2024041.50

To: Brad Kosco, PE, PS – City of
Hudson

Technical Memorandum: Brandywine Creek Watershed Flood Reduction Study

Comment Responses

Figure 2: Alternative 1-Sewer Improvements for 10-yr Design Storm

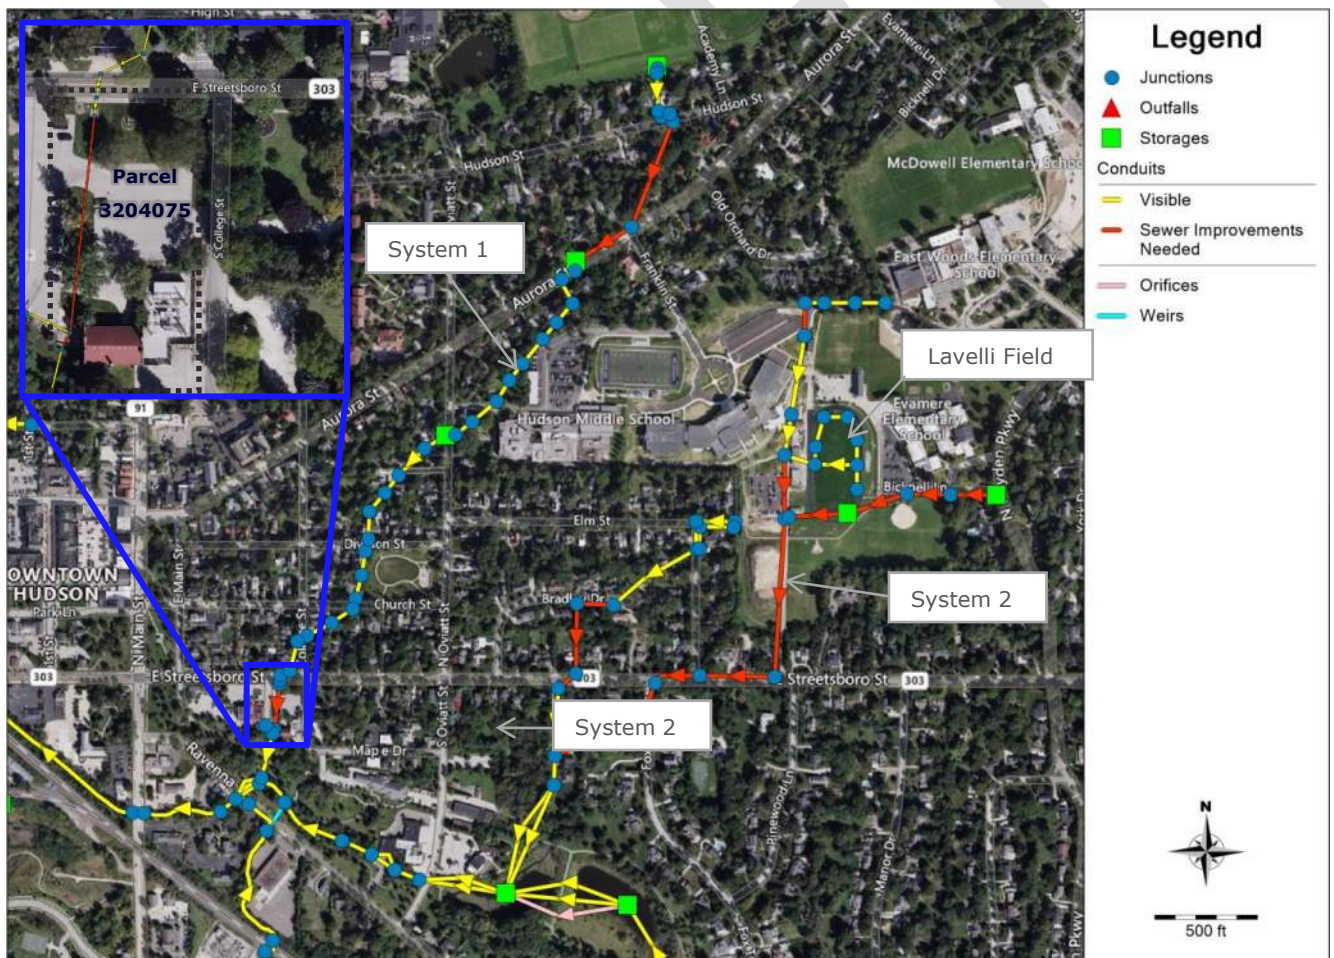
City Comment: Would a 6-ft x 4-ft culvert work at the choke point instead of the 8-ft x 4-ft culvert modeled?

GPD Response: Alternative 1 – A 6-ft x 4-ft box culvert would work, however, 8-ft x 4-ft was chosen to align with downstream culvert.

Existing 100-yr System 1

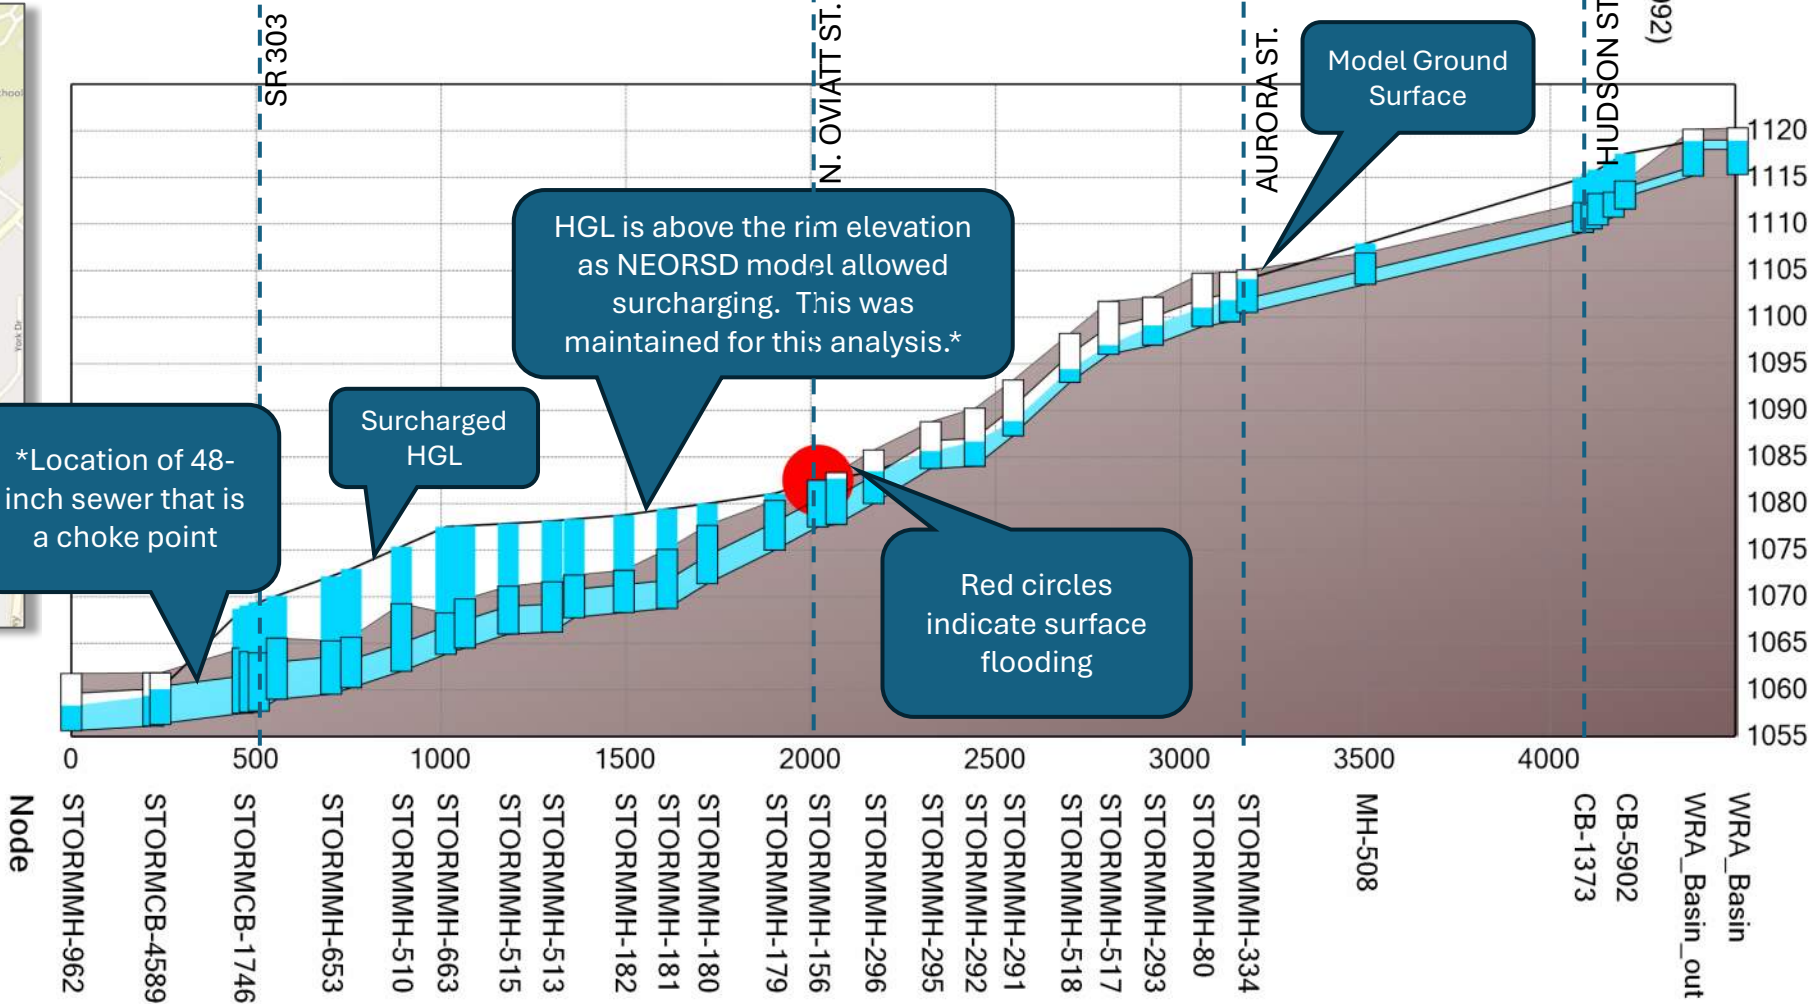
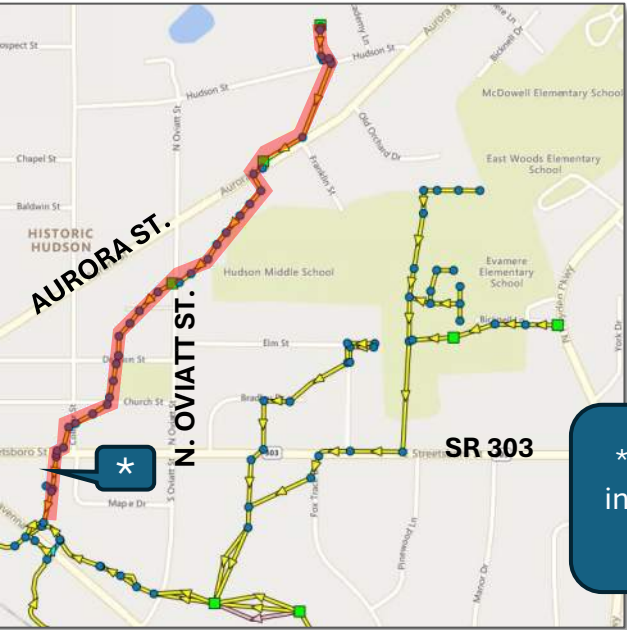
City Comment: In reference to the Existing 100-yr System 1 figure in Attachment A - why did the NEORSD allow system surcharging before flooding occurred?

GPD Response: We believe that NEORSD allowed system surcharging to keep flow from leaving the system. In PCSWMM, when node flooding occurs, that flow is "lost" from the system. NEORSD wanted to evaluate the overall watershed and stream hydraulics in the master plan and so they allowed the surcharging to ensure that all the flow made it to the larger streams they were studying in more detail. In subsequent master plan models, NEORSD has

started utilizing overland flow conduits and/or two-dimensional elements to allow flow to surcharge out of the sewer, but not surcharge and artificially increase the HGL.

Alternative 2
100-yr System 1

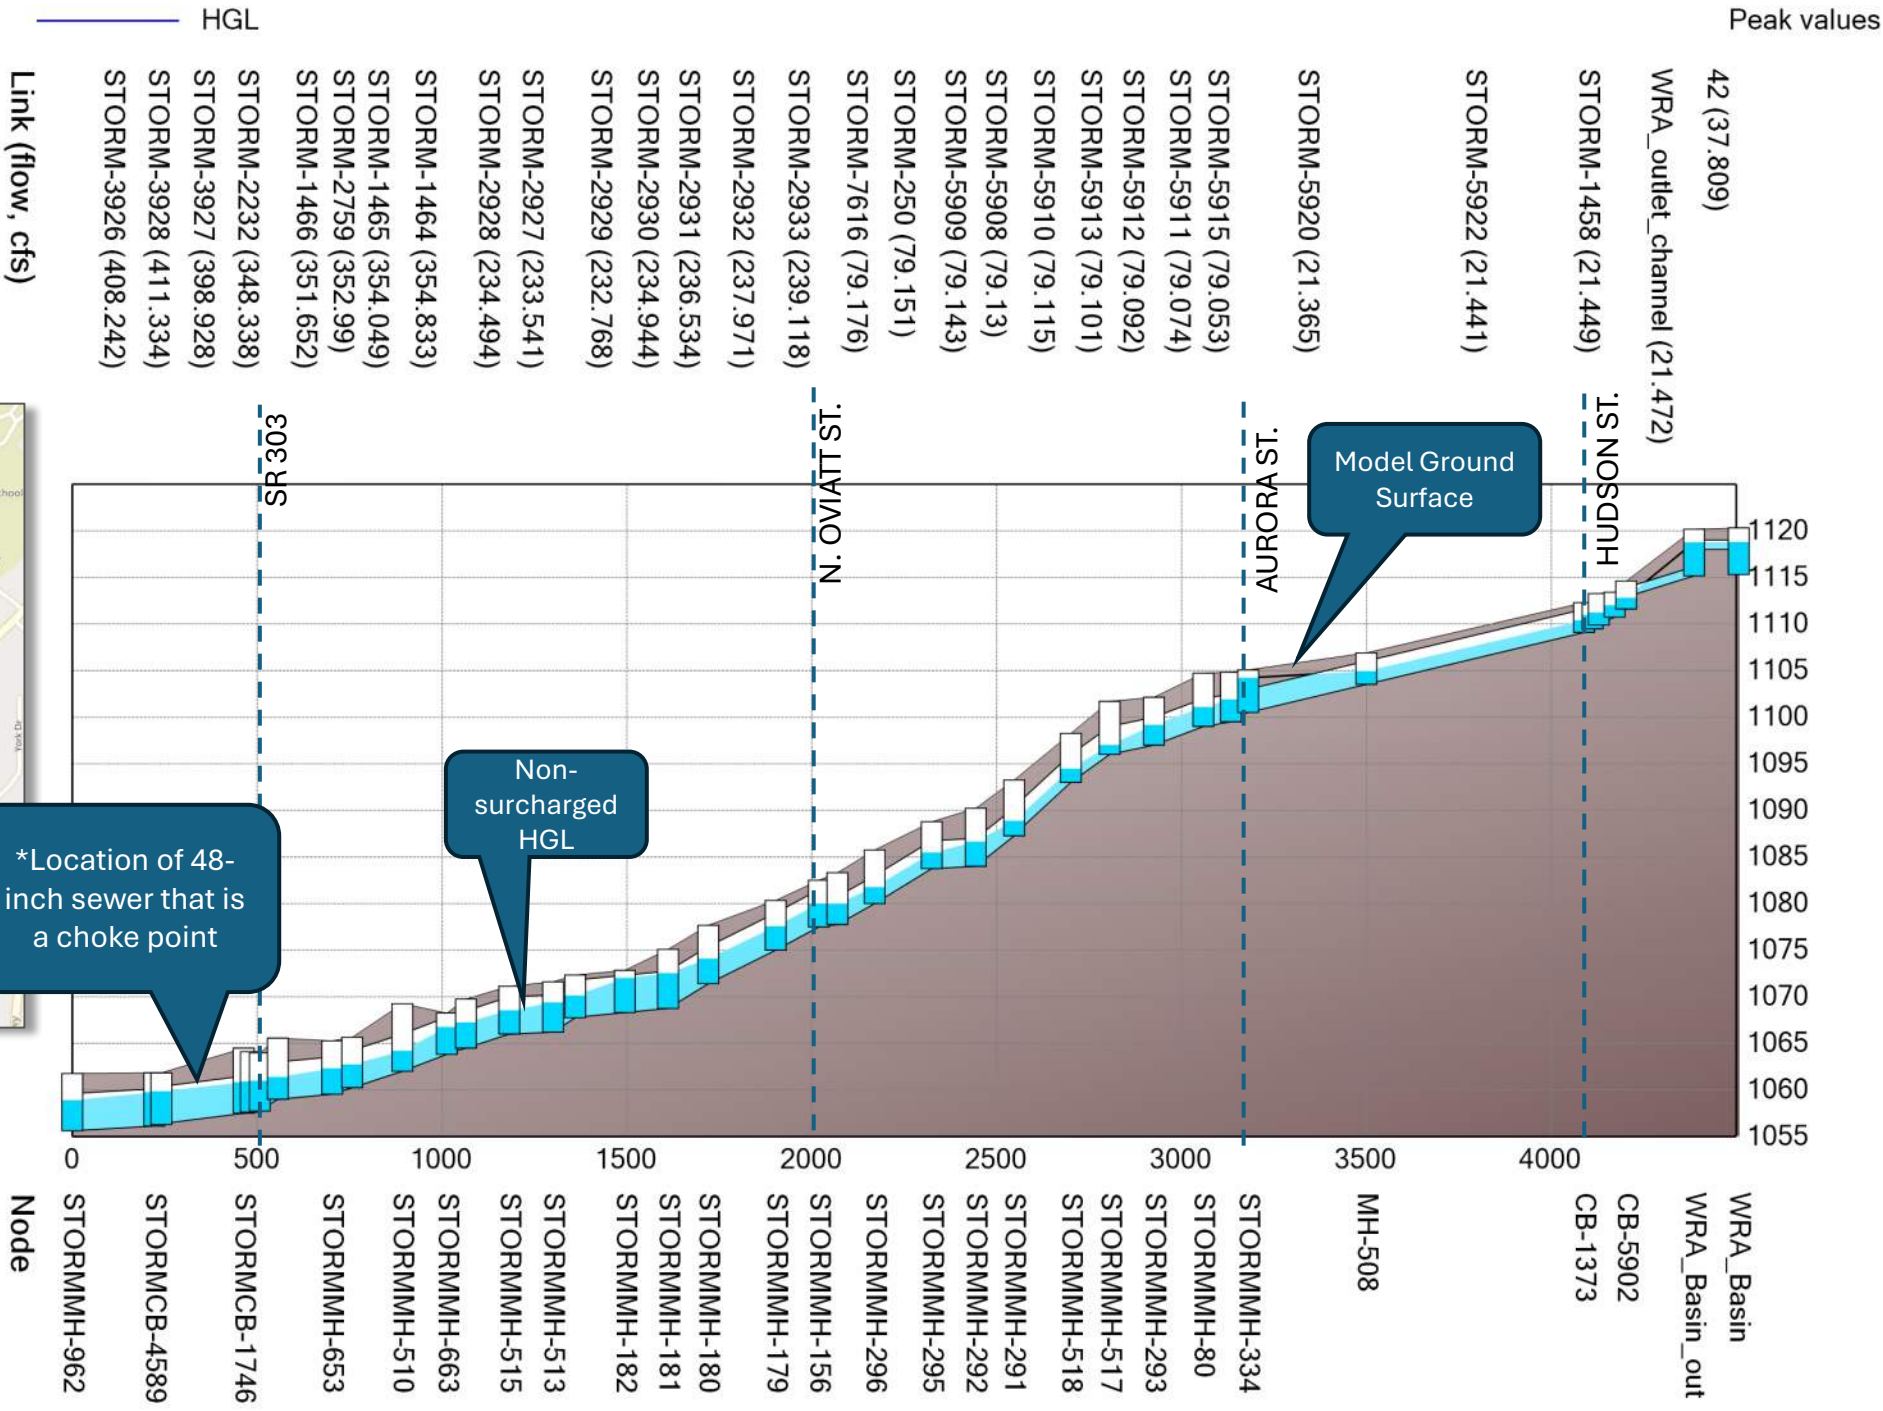
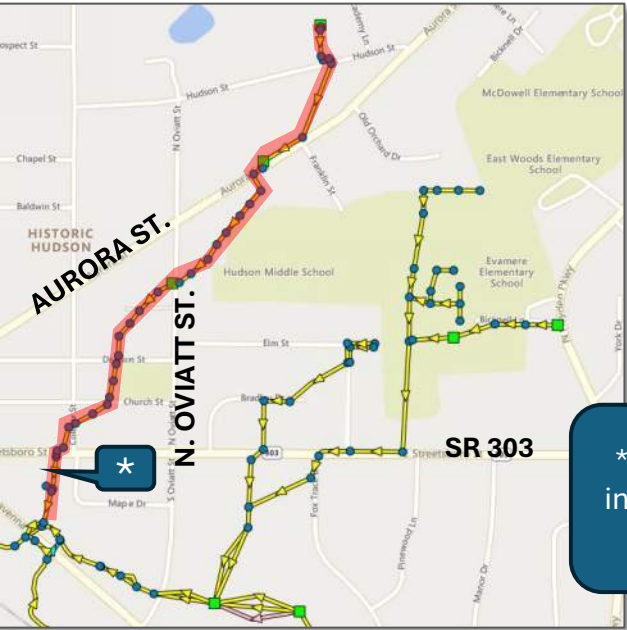
City Comment: Was the size of pipe required to eliminate surcharge for the 100-yr event in system 2 identified? (This was in reference to Alternative 2.)

GPD response: The slopes of the sewers were not changed between the existing and proposed condition. The surcharging for the 100-year north of E. Streetsboro St. was minimal and it is likely that more consistent slopes would allow the system to function without surcharging. South of E. Streetsboro St. System 2 discharges through a 6-ft by 5-ft horizontal elliptical pipe into the Barlow Community center ponds. The horizontal elliptical pipe has an outlet invert elevation of 1060-ft. During the 100-year storm, the max HGL at the Barlow ponds reaches 1071.83-ft, resulting in a backwater effect that reaches to E. Streetsboro St. Due to the backwater from the ponds, the 6-ft by 5-ft horizontal ellipse was not considered for replacement in the evaluated alternatives.
